ADDENDUM NO. 3
DTCC OFFICE OF THE PRESIDENT
BID PACKAGE B
Dover, Delaware 19904

March 14, 2013

The contract documents for the above referenced project, dated February 5, 2013 are amended as follows:

FINISH PLAN (ADDENDUM NO. 3)		SKA104-1
PROJECT NO.:	2012025.00	
DATE:	3/13/13	
SCALE:	1/4" = 1'-0"	
DRAWN BY:	Author

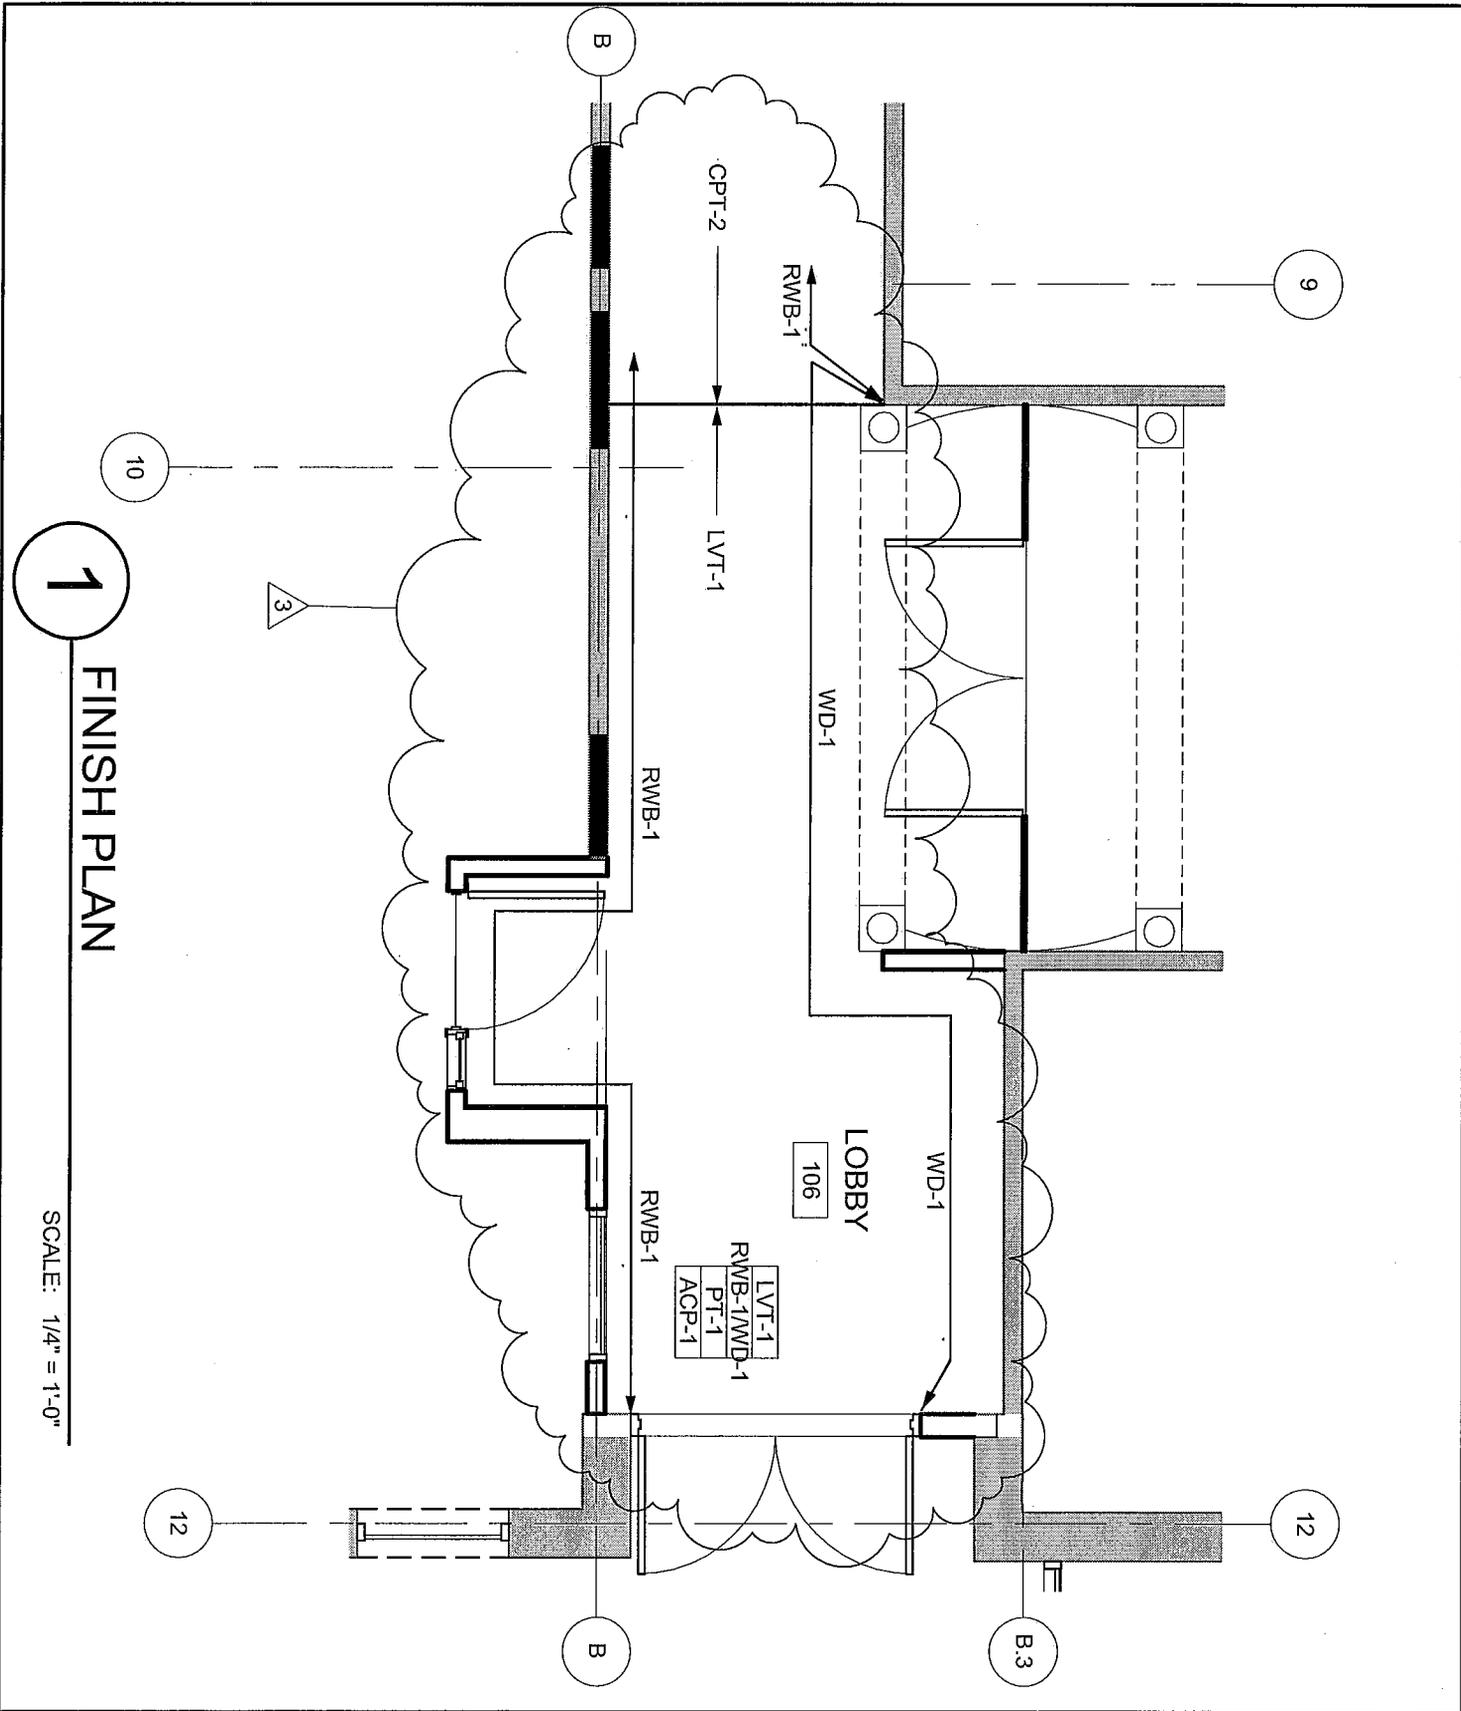
5	<p>A104; Finish Plan:</p> <ul style="list-style-type: none"> • Delete Lobby 106 as shown, Substitute as shown in revised plan as indicated in SKA104-1, date 03/13/13.
6	<p>A401; Enlarged Plans & Section:</p> <ul style="list-style-type: none"> • Interior Elevation – Lounge 126 #2; Delete dimension “3’-0””, countertop height, Substitute “2’-10””.
7	<p>A502; Interior Elevations & Details:</p> <ul style="list-style-type: none"> • Add new drawing A502, Interior Elevations & Details, dated 03/09/13.
8	<p>A601; Door & Window Types and Schedule:</p> <ul style="list-style-type: none"> • Door Schedule: <ul style="list-style-type: none"> ○ Delete door height “ 7’-10” ” for doors 110/1 & 110/2, Substitute “ 7’-8” ”. • Window/Storefront Types:

Plumbing - Domestic Water System - Mechanical Room - Partial Plan	
PROJECT NO.:	2012025.00
DATE:	03/13/2013
SCALE:	1/4" = 1'-0"
DRAWN BY:	Author

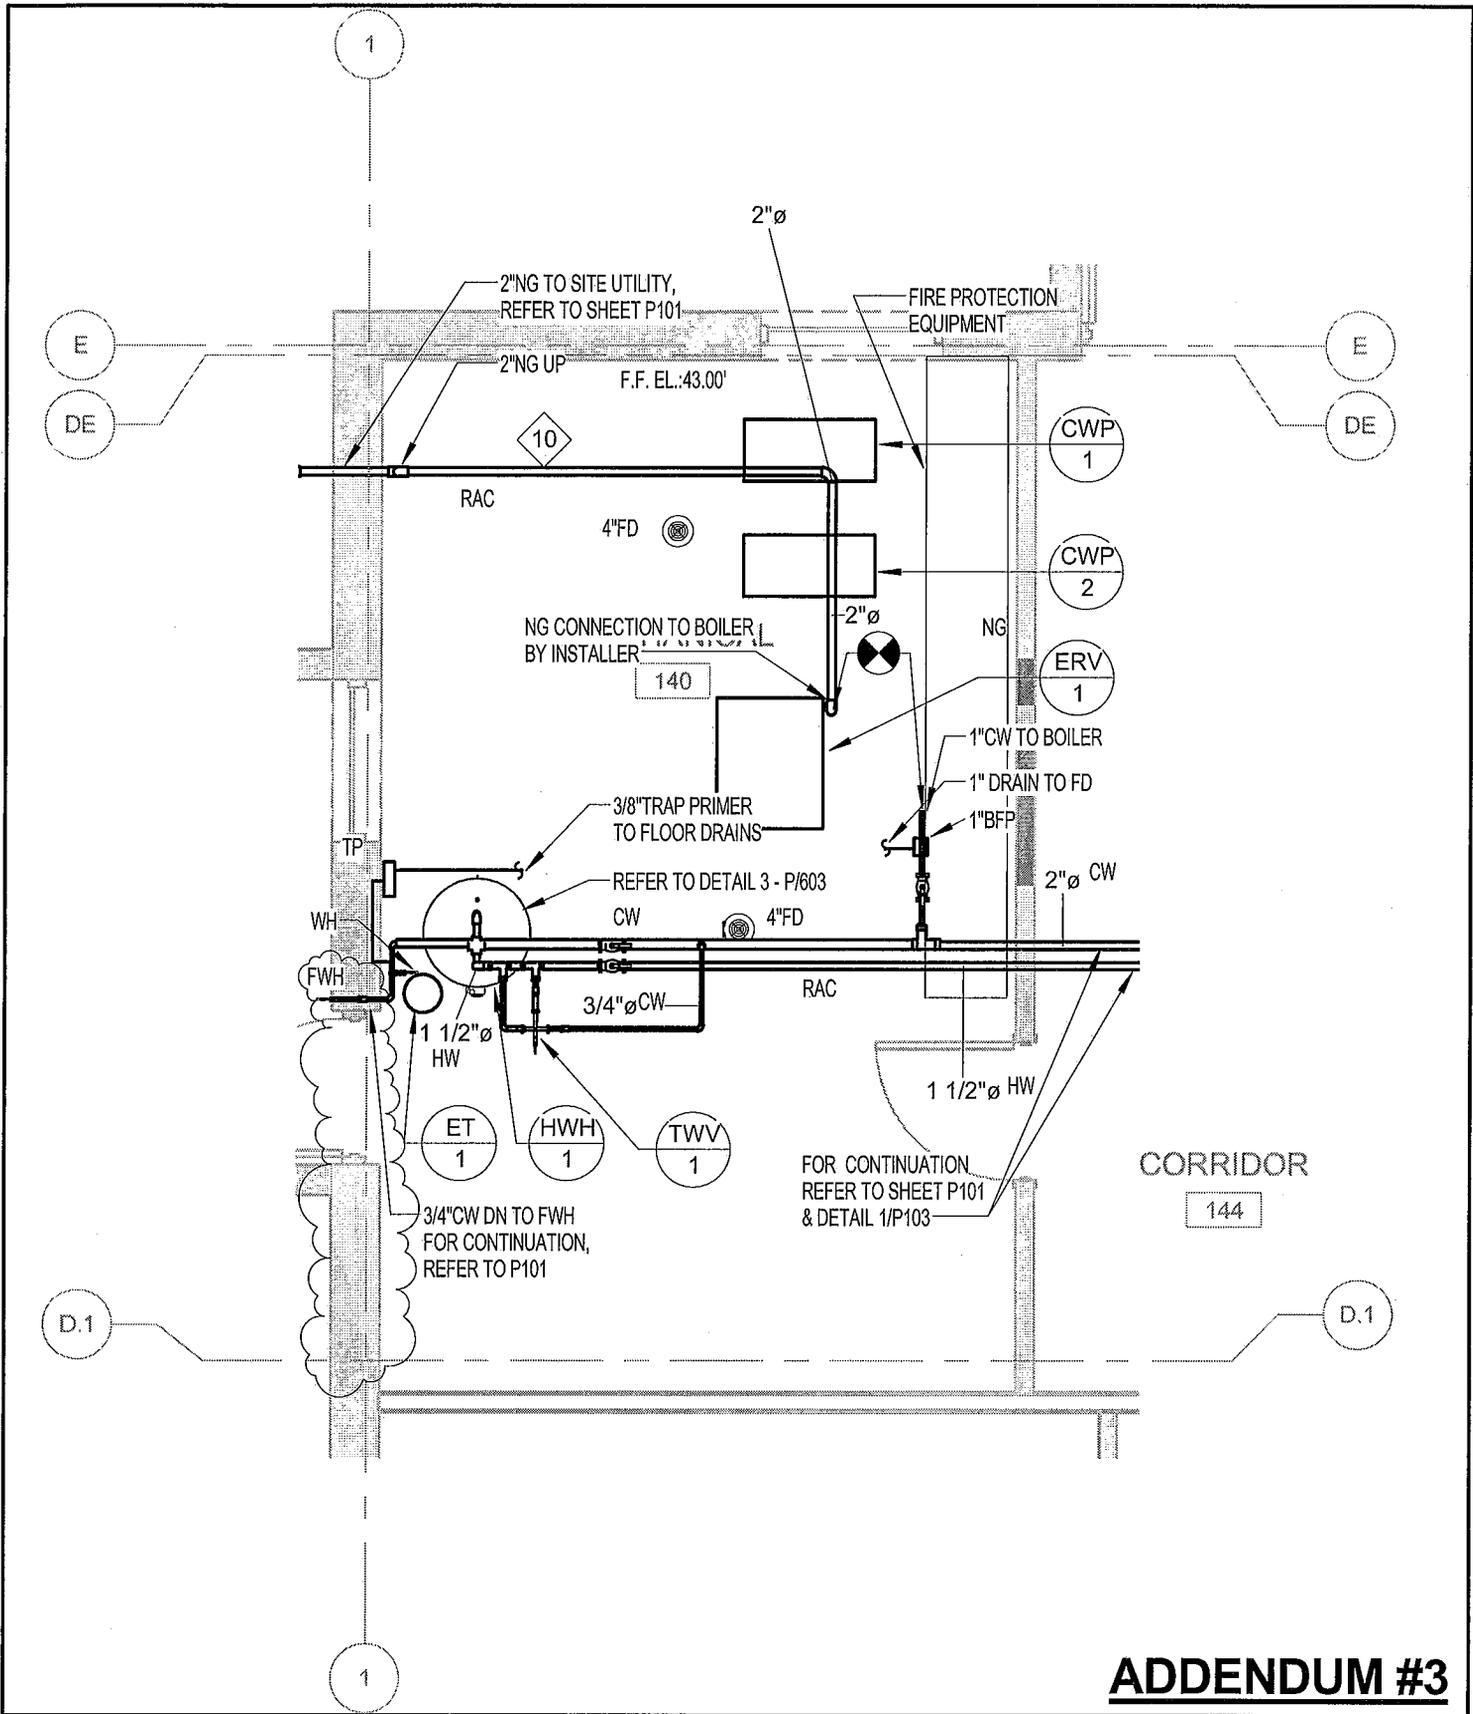
26	<p>E102; Administration Building Electrical System – 1st Floor Power Plan – New Work:</p> <ul style="list-style-type: none"> • CLARIFICATION: The dark symbols are new receptacles and the light symbols are existing receptacles to remain. • CLARIFICATION: The Condensing Unit selected for this project has one electrical feed that goes to the Indoor Unit. The Outdoor Unit is then powered from the Indoor Unit. Alternate manufacturers may require two separate feeds. • CLARIFICATION: Refer to Mechanical Drawing M101 for actual location of Energy Recovery Unit ERV-1. • CLARIFICATION: Refer to Mechanical Drawing M101 for actual location of Boiler B-1. • CLARIFICATION: Refer to Mechanical Drawing M101 for actual location of Boiler Water Pump BWP-1. • CLARIFICATION: Refer to Mechanical Drawing M101 for actual location of Exhaust Fans. • CLARIFICATION: Refer to Plumbing Drawing P104 for actual location of Condensate Pumps. • CLARIFICATION: Refer to Plumbing Drawing P104 and Sketch SKP103-2 for location of Domestic Water Heater.

Automatic Sprinkler System - Mechanical Room - Partial Floor Plan
 PROJECT NO.: 2012025.00
 DATE: 03/13/2013
 SCALE: 1/4" = 1'-0"
 DRAWN BY: Author

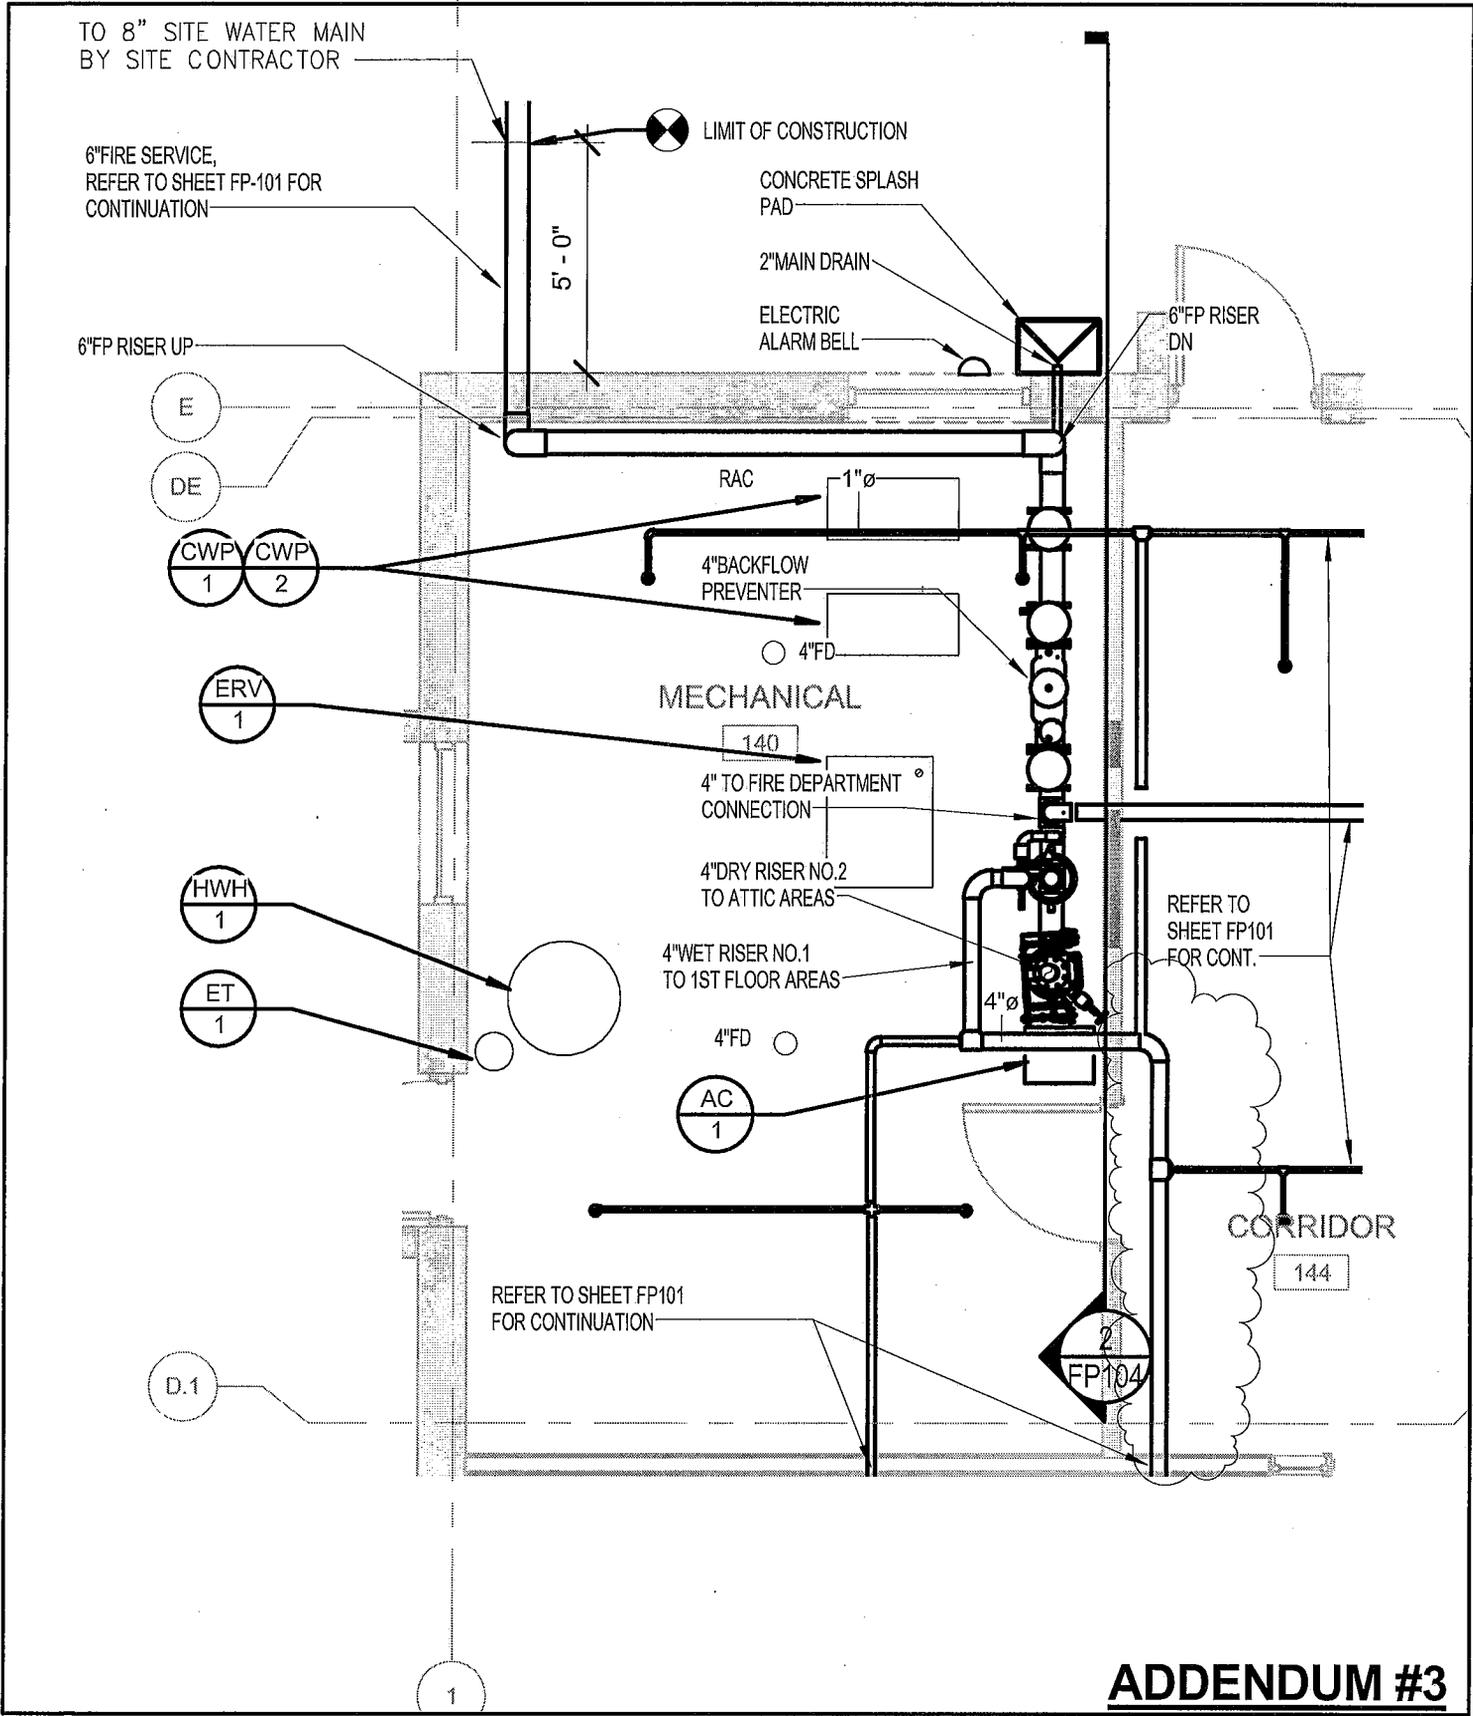
<ul style="list-style-type: none"> • ADD Sketch SKFP 104-1 to the drawing which updates the location of the Mechanical Equipment in the Mechanical Room with reference to the Fire Protection Riser.
25	<p>E101; Administration Building Electrical System – 1st Floor Lighting Plan – New Work:</p> <ul style="list-style-type: none"> • ADD the following Sheet Note: <ul style="list-style-type: none"> “5. Existing lighting with one (1) switch shall be bid under the Base Bid. In areas with two (2) switches, first switch shall be included under the Base Bid. (See Alternate Number 7 for further direction.) • ADD the following Notes for Alternate No. 7 for Inboard / Outboard switching of existing light fixtures:: <ul style="list-style-type: none"> Alternate No. 7 (Inboard / Outboard Switching for Existing Light Fixtures) <ol style="list-style-type: none"> 1. Rooms with existing lighting and two (2) switches, the second switch shall be bid under Alternate No. 7. The first switch shall be included in the Base Bid. 2. Rooms with existing lighting and two (2) switches, the Installer shall include the cost for the second ballast under Alternate No. 7 in order to achieve Inboard / Outboard lighting operation. 3. Existing lighting with one (1) switch shall be bid under the Base Bid. • CLARIFICATION for re-installation of the existing 2x4 lighting fixtures: Approximately forty-three (43) of the existing light fixtures have parabolic lenses and forty-six (46) prismatic lenses. Contractor shall re-install similar fixtures in a given room or office. A revised lighting plan identifying which offices / rooms get prismatic fixtures and which offices / rooms get parabolic fixtures will be issued to the successful Electrical Installer during construction: • CLARIFICATION for Meeting Room 123: Existing lighting fixtures in Meeting Room 123 are not 2x4 lighting fixtures. There are four (4) down lights and one (1) four (4) foot round fluorescent fixture. These fixtures are to be removed and turned over to the Owner. Contractor shall provide two (2) additional A1 fixtures for installation under new work including wire & labor:

Partial Fire Alarm Plan - Room 143		SKE103-1
PROJECT NO.:	2012025.00	
DATE:	03/13/2013	
SCALE:	1/4" = 1'-0"	
DRAWN BY:	Author

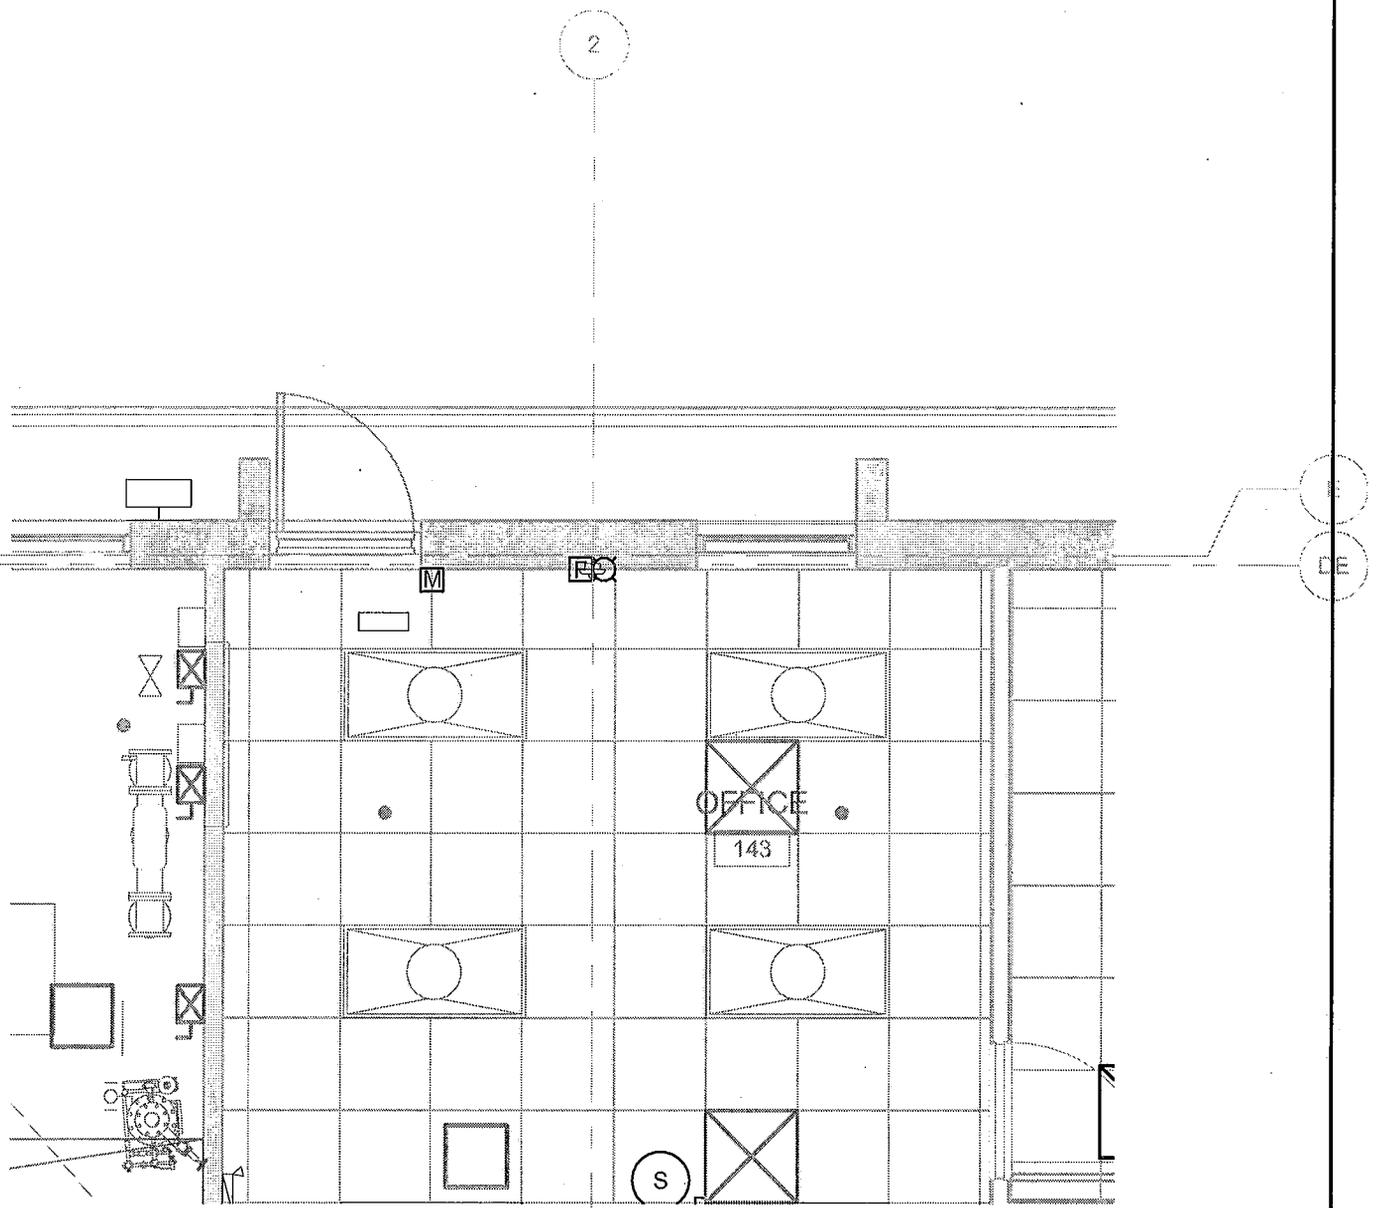
27	<p>E103; Administration Building Electrical System – 1st Floor Power Plan – New Work:</p> <ul style="list-style-type: none"> • ADD Sketches SKE 103-1 and SKE 103-2 MODIFYING the Fire Alarm System to the Sheet.
28	<p>E501; Electrical – Single Lone Diagrams & Lighting Fixture Schedule:</p> <ul style="list-style-type: none"> • New Work Notes; CHANGE “...and (1) 4” Spare Conduit” to read “...and two (2) Spare 4: Conduits.”
29	<p>E601; Schedules:</p> <ul style="list-style-type: none"> • Panel MDP; DELETE 30kva Transformer T-2 from Schedule and REPLACE with Spare. • CHANGE Transformer T-1 from 75kva to read 112.5kva”.
30	<p>E602; Schedules:</p> <ul style="list-style-type: none"> • Panel RP2: <ul style="list-style-type: none"> ○ PROVIDE 100 amp/3P Circuit Breaker in Panel RP2 in order to feed Panel LPB. ○ PROVIDE 20 amp/3P Circuit Breaker in Panel RP2 in order to feed the BWP-1
